PROJECT: Alabama A&M University
Fine Arts Building
Interior Finishes Upgrades
Studio 2H Design Project No. 202002

03/24/2020 - Addendum #1

REQUEST FOR INFORMATION (RFI) LOG - BIDDING

A2.1 NORTH

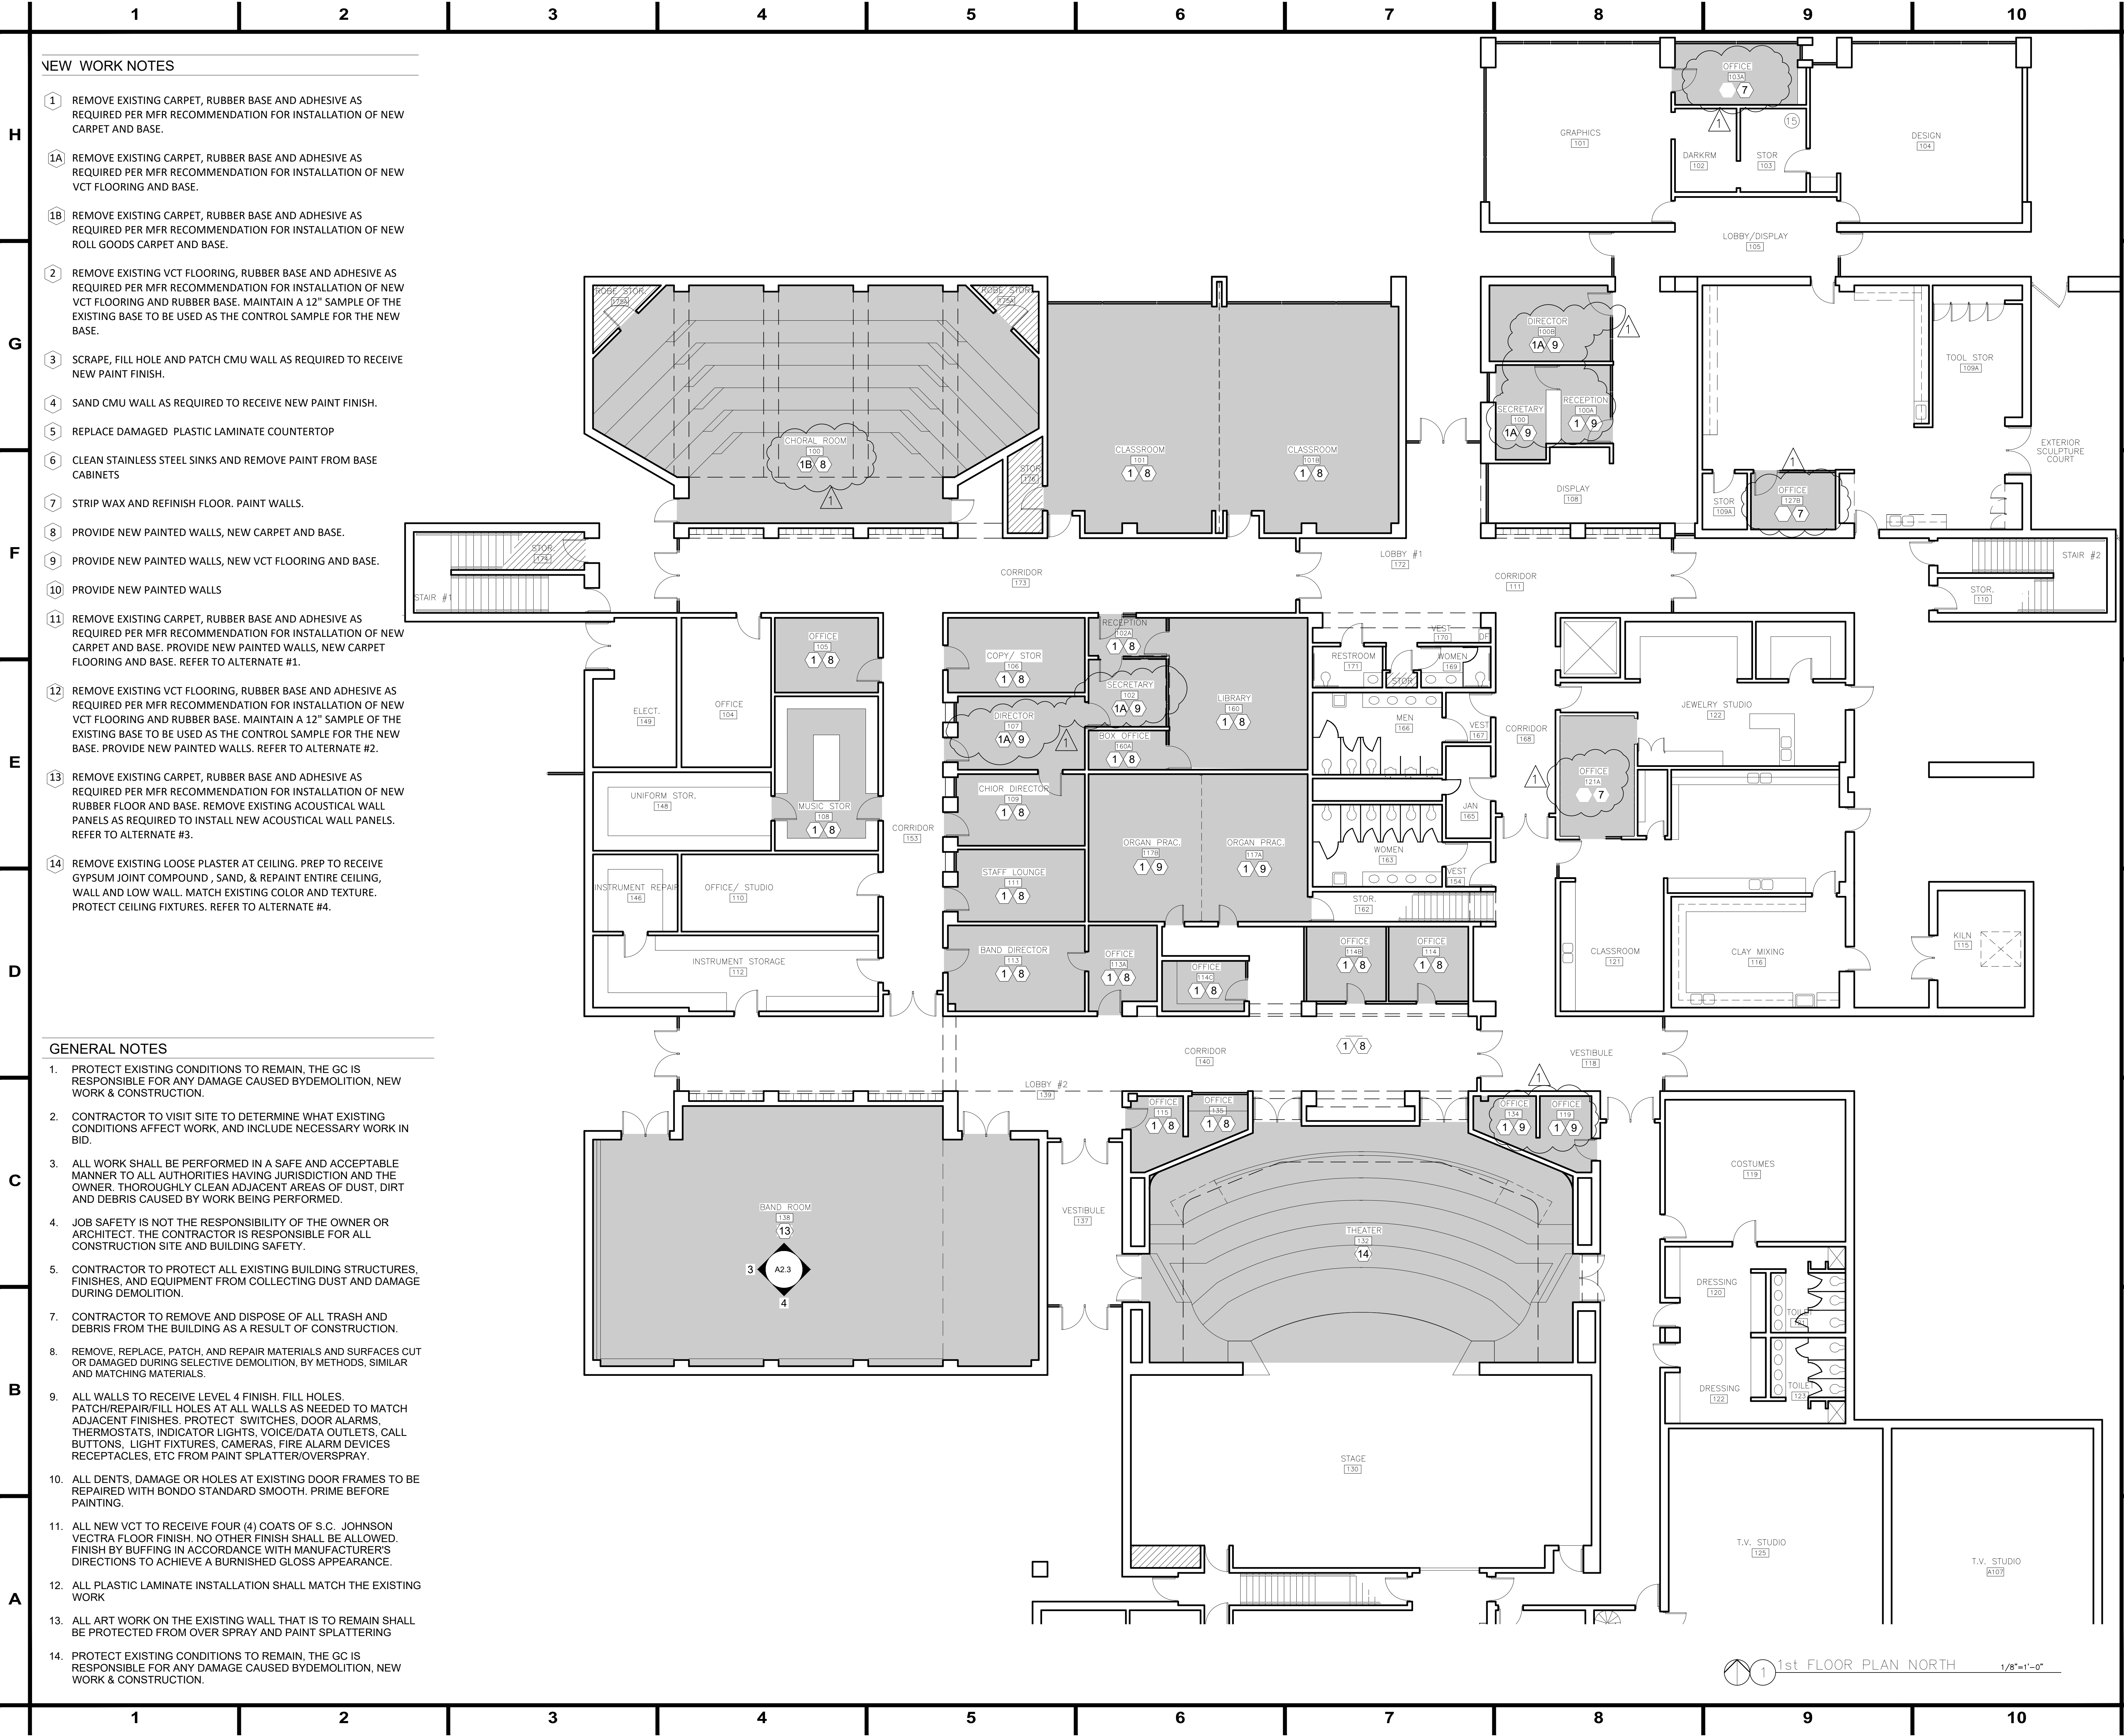
3. Corridor #140 has the work note symbol 1 & 8, but it is not shaded. Are we to include this area also? If so where would the stopping point be.
 - a. **Response: Notes #1 & #8 does not apply to #140.**

1. Sheet A2.1 NORTH: Omit Notes #1 & #8 at Rooms 102 & 107 and replace Notes #1A & #9.
2. Sheet A2.1 NORTH: Omit Note #1 & #8 at Rooms 103A, 121A & 127B and replace with Note #7
3. Sheet A2.1 NORTH: Omit Note #1 & #8 at Rooms 100, 100A & 100B and replace with Notes #1A & #9
4. Sheet A2.2 NORTH: At Rooms 216 & 217 add Note #6. At Rooms 216A and 218 omit Note #8 and replace with Note #9
5. Sheet A2.2 NORTH: Change Studio 209A to Office 209A and add Notes #2 & #9.
6. Sheet A2.1 NORTH: Omit Notes #1 & #8 at Room 119 and 135 and replace with Notes #1A & #9.

RFI NO.	RFI DATE	PARTY REQUESTED BY	DRAWING/SPEC REFERENCE	INFORMATION REQUEST - QUESTION	RESPONSE BY	RESPONSE DATE	ARCHITECT/ENGINEER RESPONSE
1	3/12/20	AAMU	A2.1 North	Replace the carpet in Rooms 102 & 107 with tile	S2HD	Addn1 - 3/24/20	Omit Notes #1 & #8 at Rooms 102 & 107 and replace Notes #1A & #9.
2	3/12/20	AAMU	A2.1 North	No Carpet in Offices 127B, 121A, 103 or 103A. These currently have only tile and should remain that way.	Note #6	Addn1 - 3/24/20	Omit Note #1 & #8 at Rooms 103A, 121A & 127B and replace with Note #7
3	3/12/20	AAMU	A2.1 North	No Carpet in 100, 100A or 100B would like tile instead	S2HD	Addn1 - 3/24/20	Omit Notes #1 & #8 at Rooms 100, 100A & 100B and replace Notes #1A & #9.
4	3/12/20	AAMU	A2.2 North	Room 217 when you replace the cabinets, only replace the bottom ones. The new sinks in 217 should be utility sinks	S2HD	Addn1 - 3/24/20	At Rooms 216 & 217 add Note #6. At Rooms 216A and 218 omit Note #8 and replace with Note #9

A2.2 NORTH

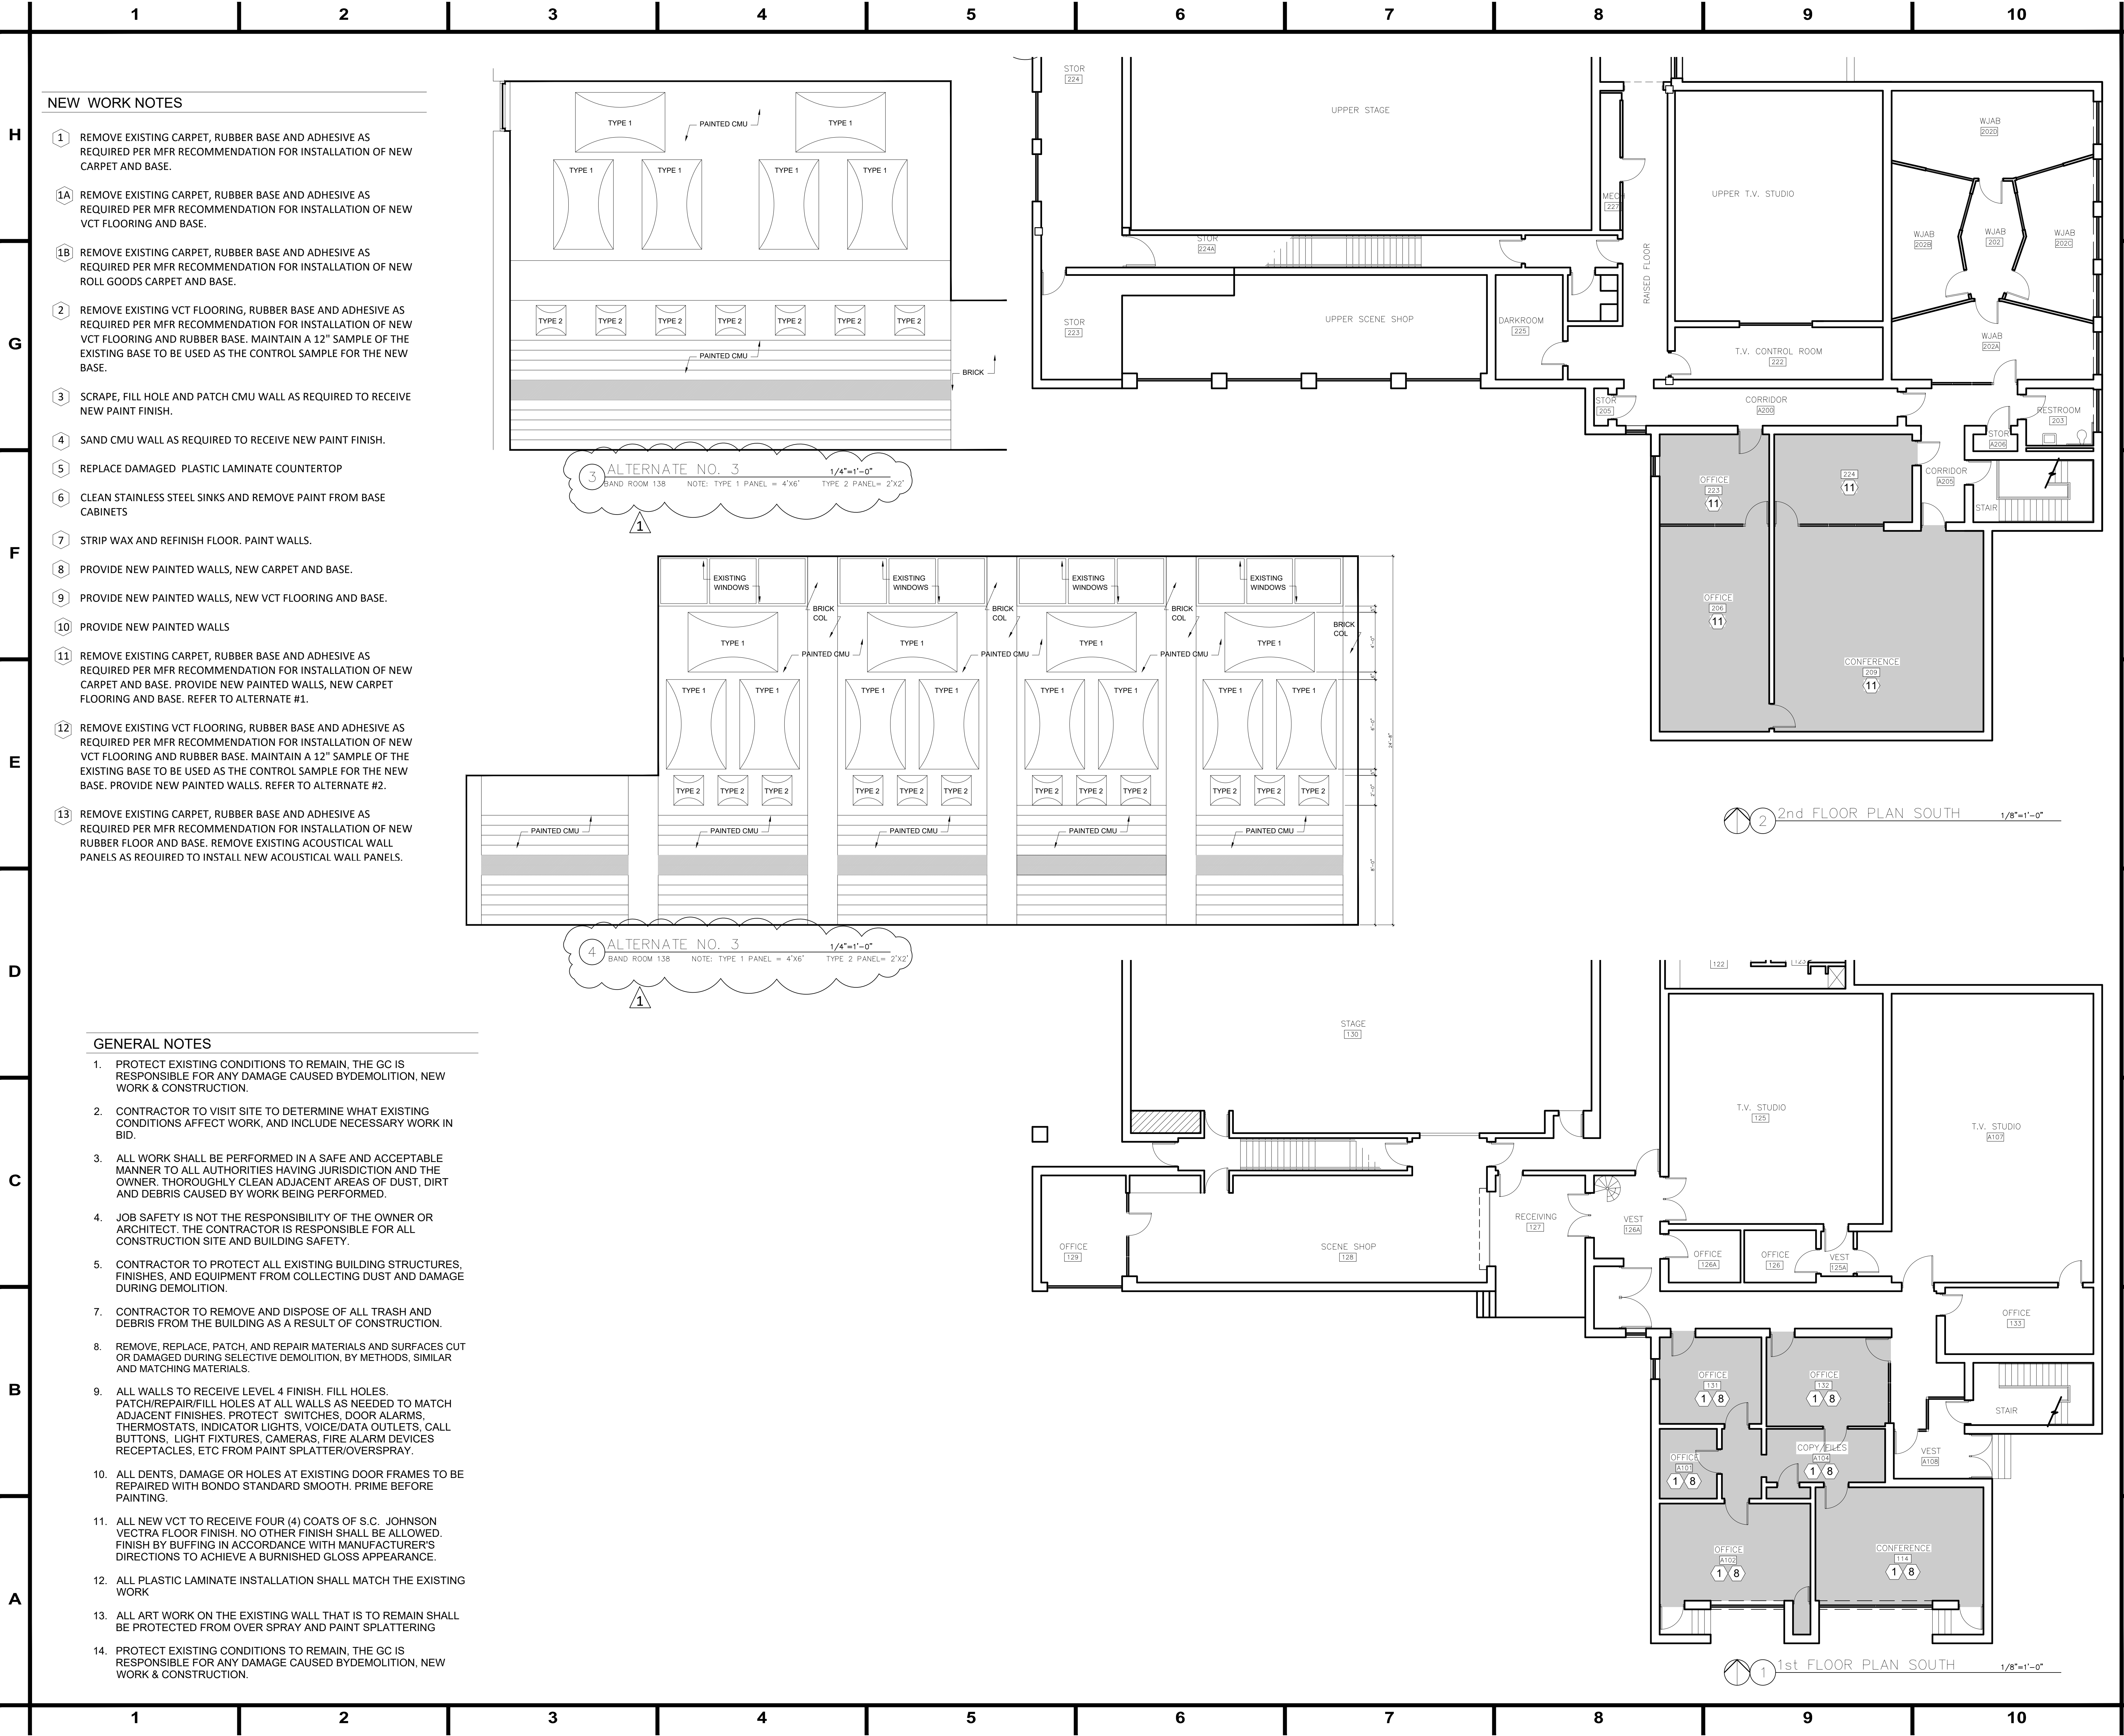
5	3/12/20	AAMU	A2.2 North	Room 209A is marked Studio but it actually an Office & will need to be painted and they are requesting tile instead of carpet.	S2HD	Addn1 - 3/24/20	Change Studio 209A to Office 209A and add Notes #2 & #9.
6	3/12/20	AAMU	A2.1 North	Replace the carpet in Room 119 and 135 with tile	S2HD	Addn1 - 3/24/20	Omit Notes #1 & #8 at Room 119 and 135 and replace with Notes #1A & #9.
7	3/13/20	Garber Const. Co.	Spec	What is the amount for Liquidated Damages	S2HD	Addn1 - 3/24/20	Refer to the Supplement to the General Conditions of the Contract
8	3/13/202	Garber Const. Co.	A2.1 North, A2.2 North, A2.3 South	Need clarification on the door frames, under General Notes #10. is this for all the doors throughout? Only the doors with work being done in the room? Do we include the corridor side of the door.	S2HD	Addn1 - 3/24/20	General Note #10 apply to every door frame in the building and includes the room and corridor side. It also includes the transom above the doors where they occur.
